MEMORANDUM

RE: Planning Department Recommendations

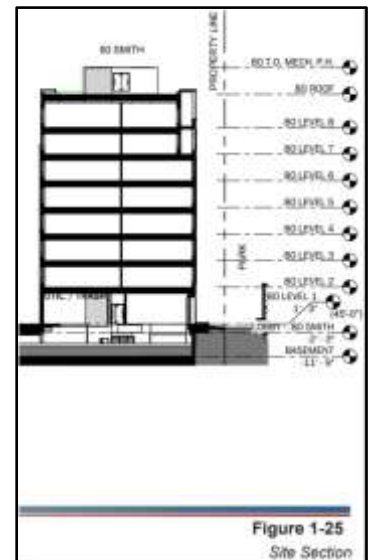
Figure 1-25 Site Section appears to show 80 Smith Street in relation to the property line. This section does not include height or setback width as it changes along the facade. It does not show balconies, private yards or landscaping and trees. *This information should be provided.*

The plans indicate that there will be a landscaped buffer between the building at 80 Smith Street and the playground. The plans show eight trees in this buffer. However, even the site plan shows the tree canopies to be severely truncated. It is unclear whether the trees proposed in this buffer would be viable. *Further detail should be provided.*

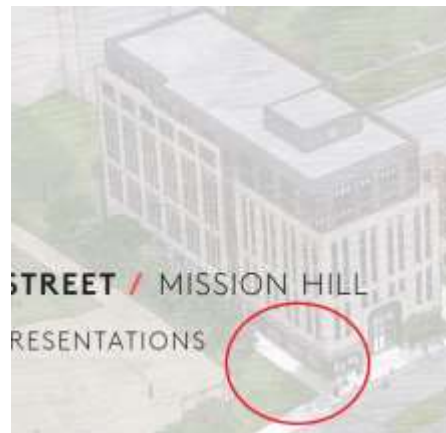
Roof Deck The roof deck at 80 Smith Street appears to be sited such that it will create an inappropriate sense of privatization from the park perspective. *Further details of the design of the proposed roof deck overlooking the playground should be provided.*

Noise and Exhaust The 2005 site plans showed the ground floor plan with a garage exhaust next to the ball field. The 2024 basement plan and ground floor plan do not include the location of the exhaust ventilation. *The location of the garage exhaust ventilation should be provided.*
